Newcastle Inner City Bypass
Rankin Park to Jesmond

**Newcastle Inner City Bypass –
Rankin Park to Jesmond
Submissions and preferred
infrastructure report**

June 2018

Figure 5-11c
 Drainage infrastructure

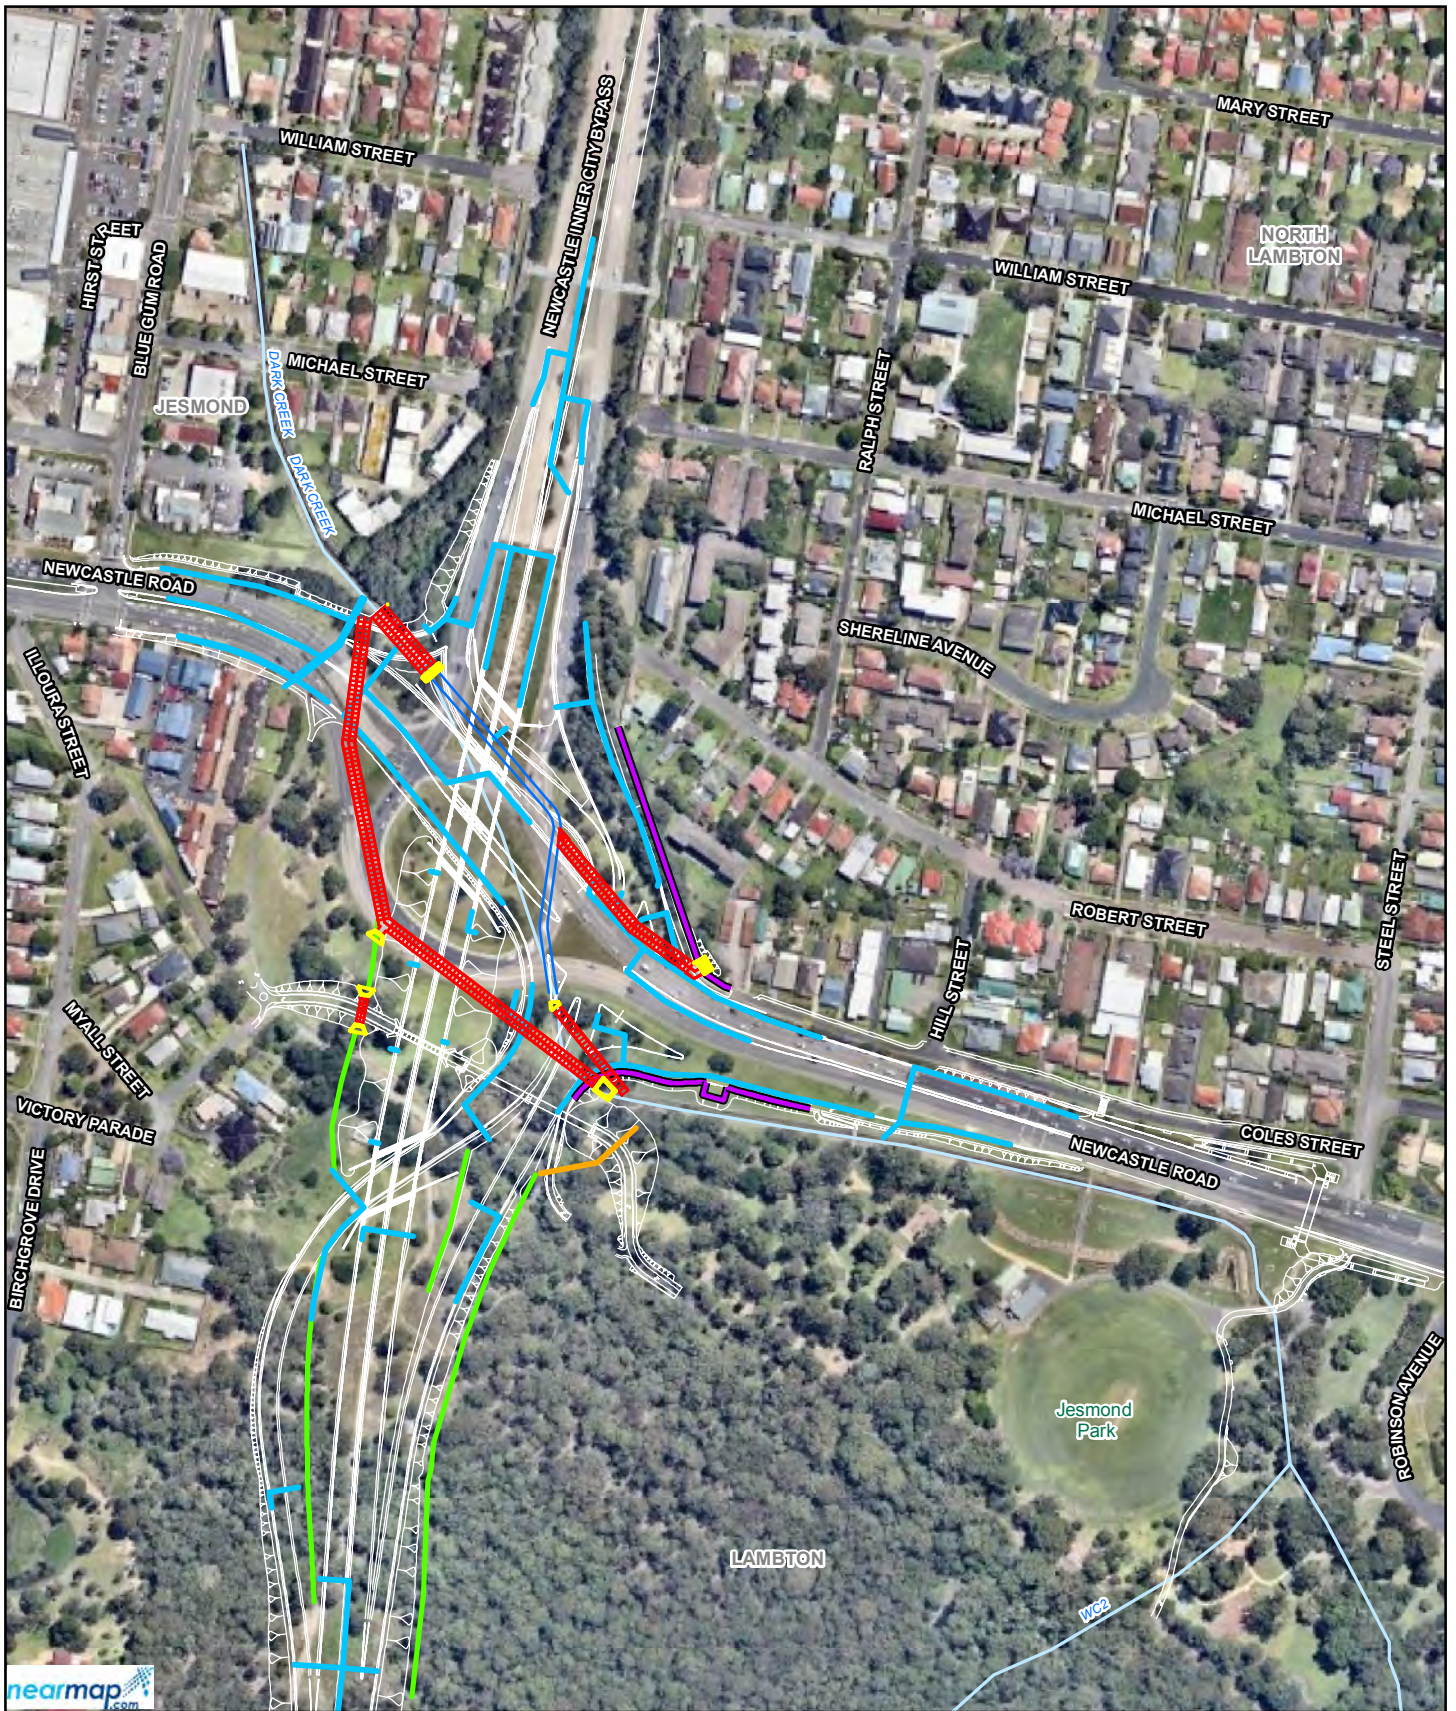
Due to the design refinements discussed in this report the proposed drainage infrastructure has now been refined as shown in Figure 5-11. The refined design is consistent with that described in the EIS and includes minor changes to cross drains, pavement drains and longitudinal catch drains to reflect other design refinements including the:

Due to the design refinements discussed in this report the proposed flood mitigation work has now been refined as shown in Figure 5-11 and consists of:

Figure 5-12
 Proposed road corridor

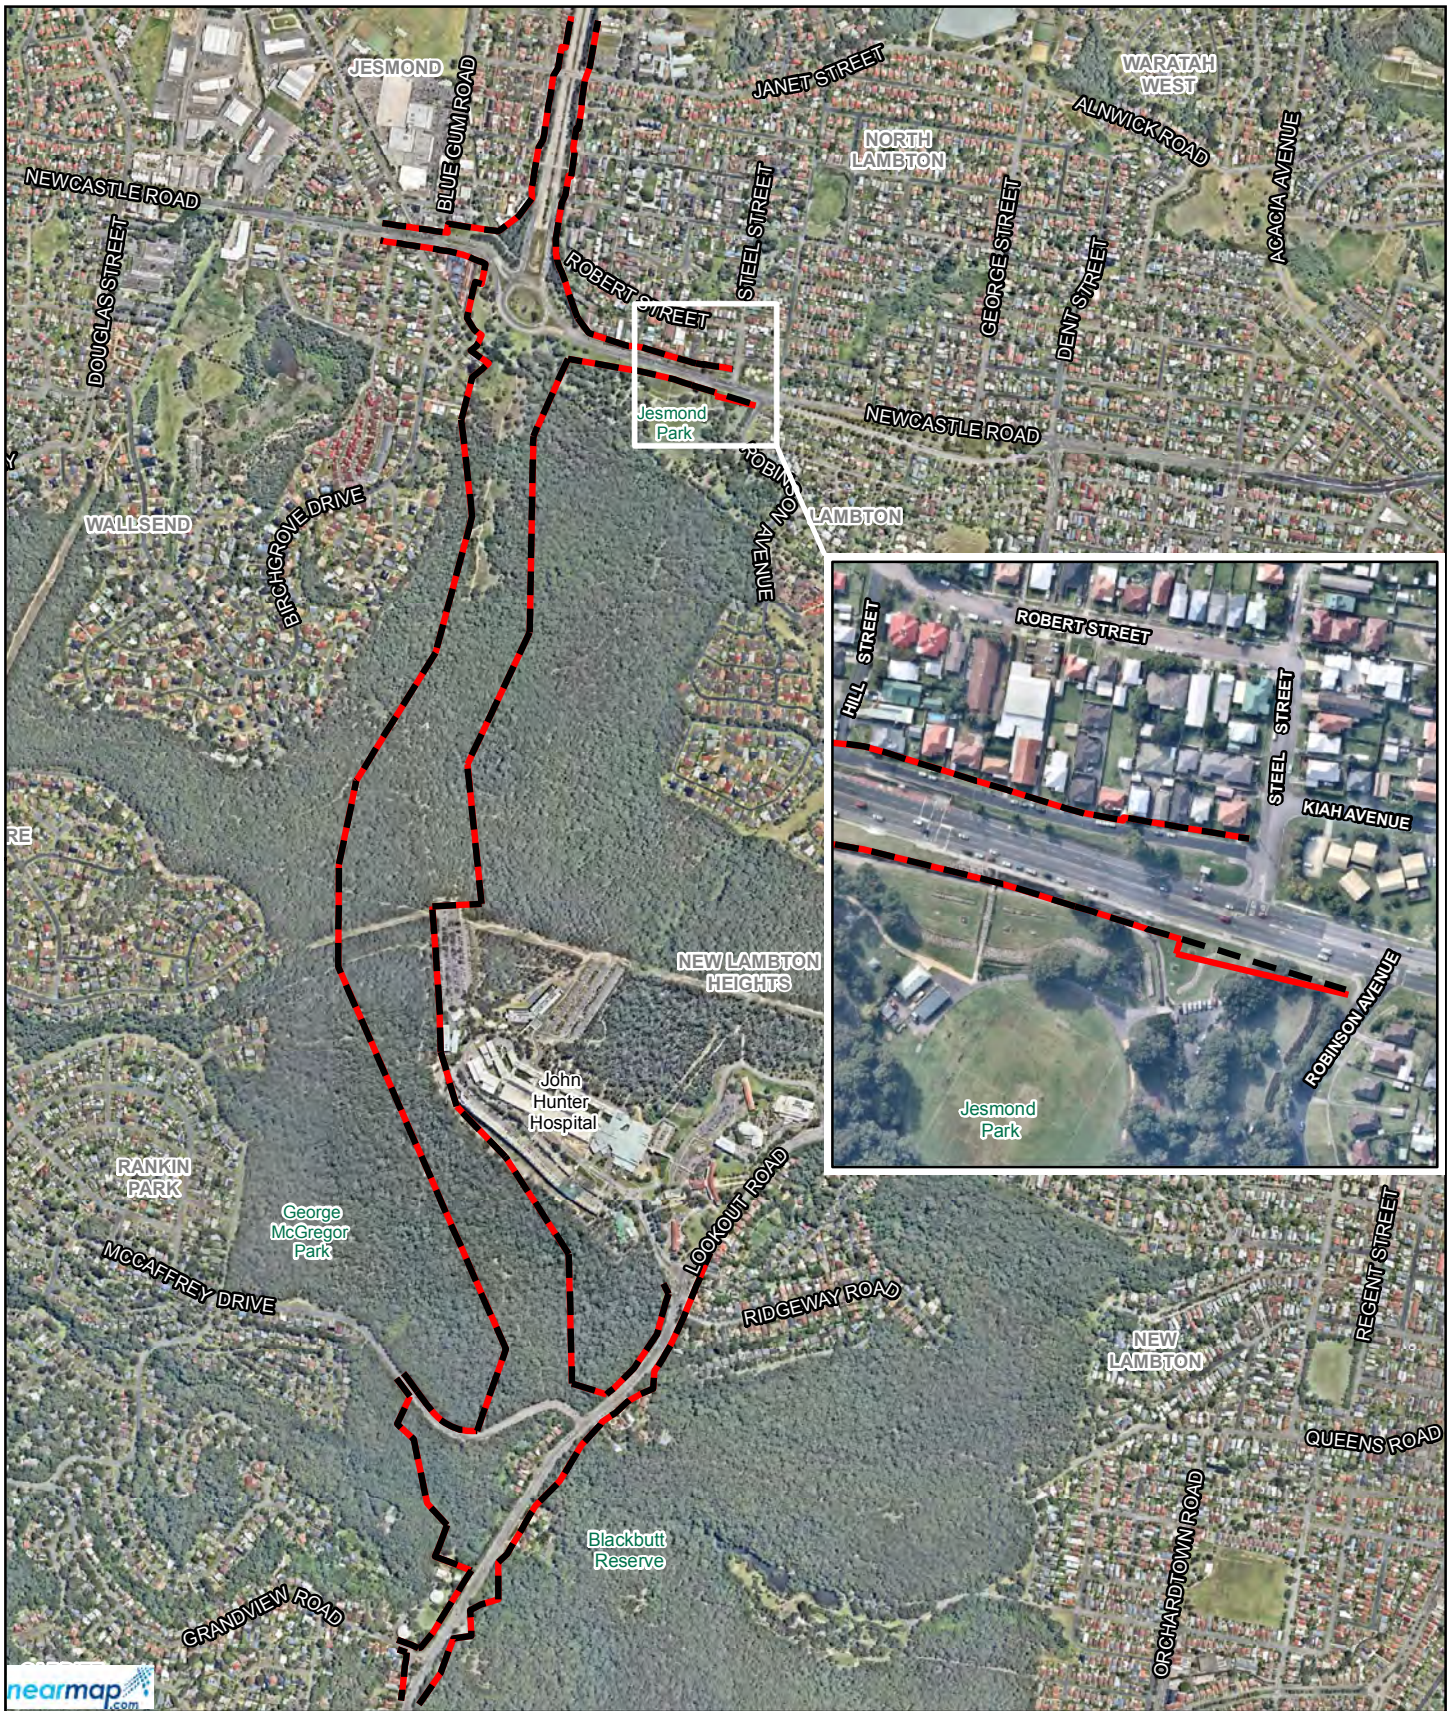
The refined proposed road corridor is shown in Figure 5-12.

Figure 5-14
 Construction footprint

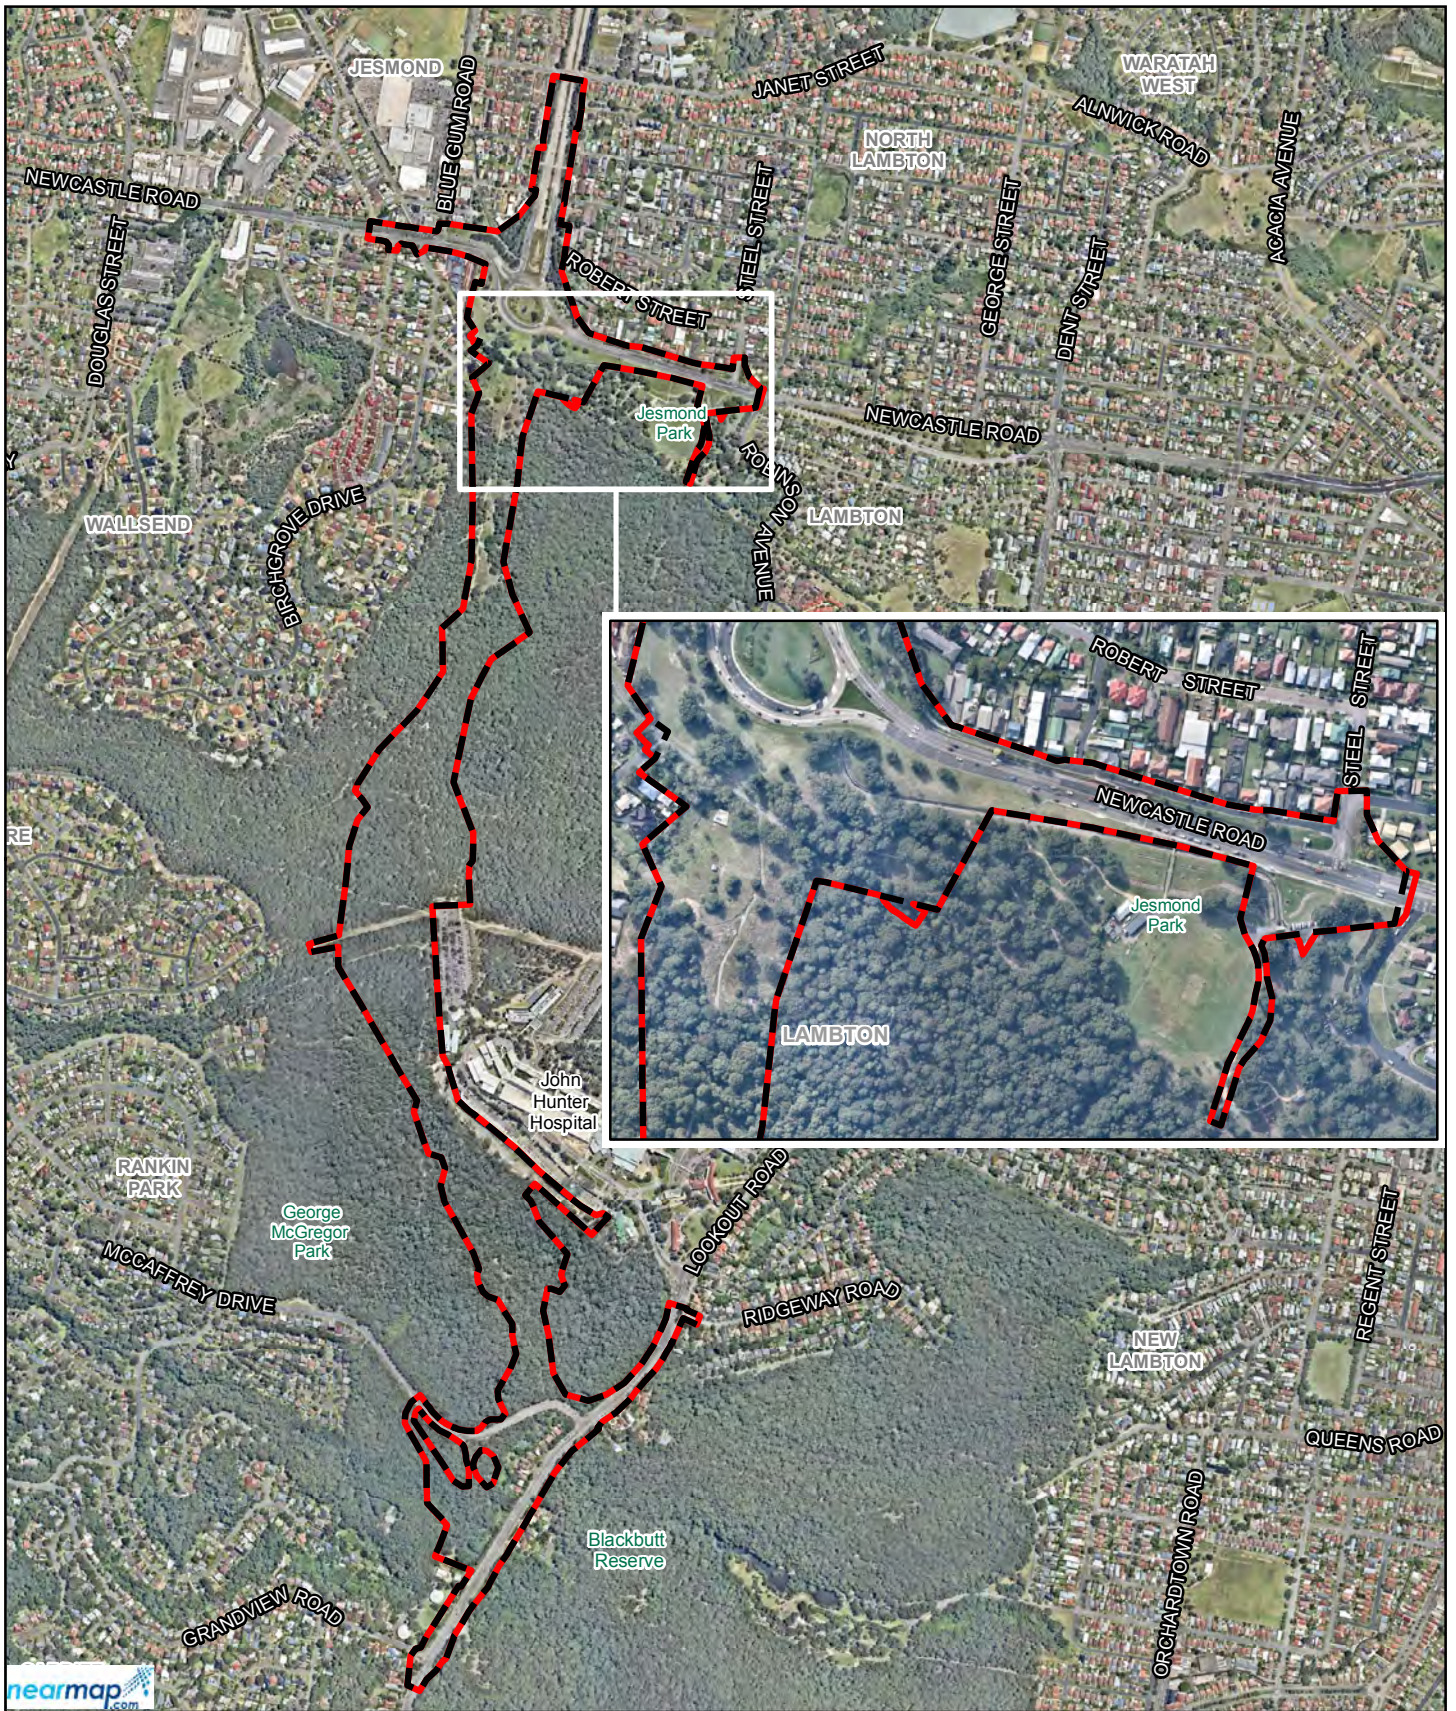
As a result the area contained within the construction footprint has increased from about 63.1 hectares to about 63.2 hectares. The refined construction footprint is shown in Figure 5-14.
